Informal document No. GRSP-49-07  
(49<sup>th</sup> GRSP, 16-20 May 2011  
agenda item 10.)

**Proposal for amendments to ECE Regulation No. 16**  
**(Safety-belts)**

The following document transmitted by OICA contains a first draft proposal to amend ECE Regulation No. 16, in order to take into account the development of a new ECE Regulation on Child Restraint Systems. This proposal is aimed at ensuring compatibility between vehicles and the child restraint systems complying with the new draft Regulation.

i-size draft v 5.0, OICA, 04.05.2011

**Figure 8 - Side view of the support leg installation assessment volume for compatibility assessment of i-Size seating positions with support legs of i-Size child restraint systems**

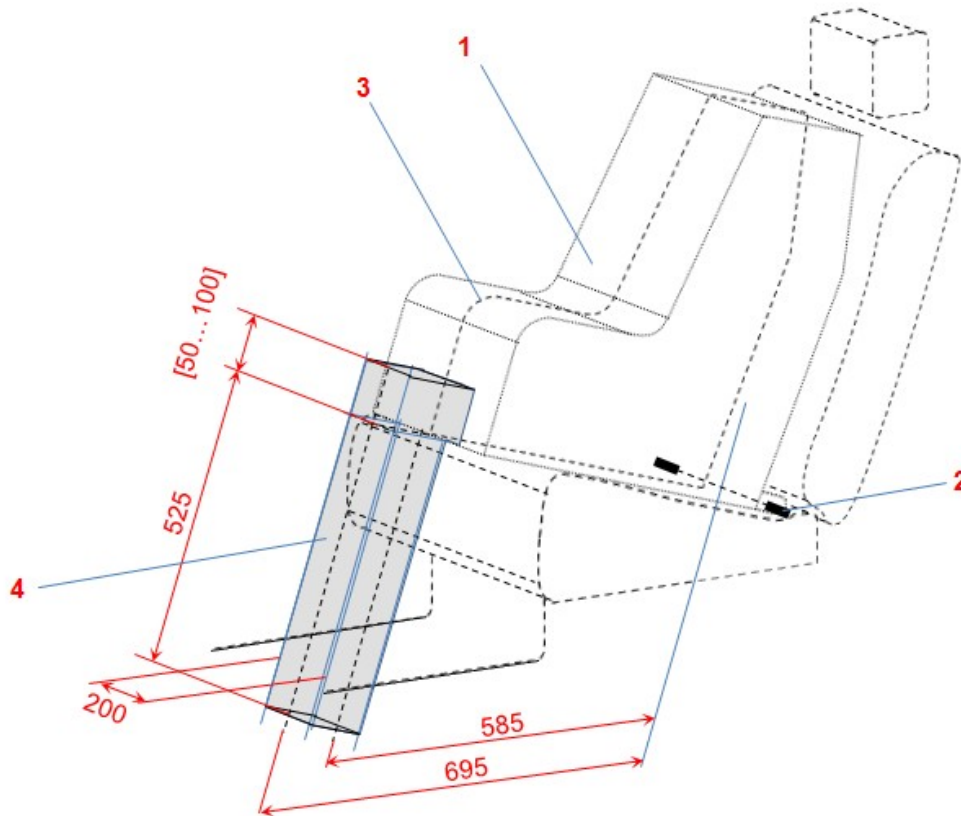
**The support leg installation assessment volume is characterized as follows (see also annex 17, appendix 2, figure 8 and 9 of this Regulation):**

**Lateral limitation: By two planes parallel to and 100mm apart from the median longitudinal plane of the child restraint fixture installed in the respective seating**

By a plane perpendicular to the plane given by the child restraint fixture bottom surface and perpendicular to the median longitudinal plane of the child restraint fixture, 695mm apart from the plane passing through the centerlines of the ISOFIX lower anchorages and being perpendicular to the CRF bottom surface; and

- Below the level of the bottom surface of the child restraint fixture by a plane perpendicular to the plane given by the child restraint fixture bottom surface and perpendicular to the median longitudinal plane of the child restraint fixture, 595mm apart from the plane passing through the centerlines of the ISOFIX lower anchorages and being perpendicular to the CRF bottom surface; and

- Above the level of the bottom surface of the child restraint fixture by a plane which is parallel to the child restraint bottom surface and [50...100]mm above this surface, and
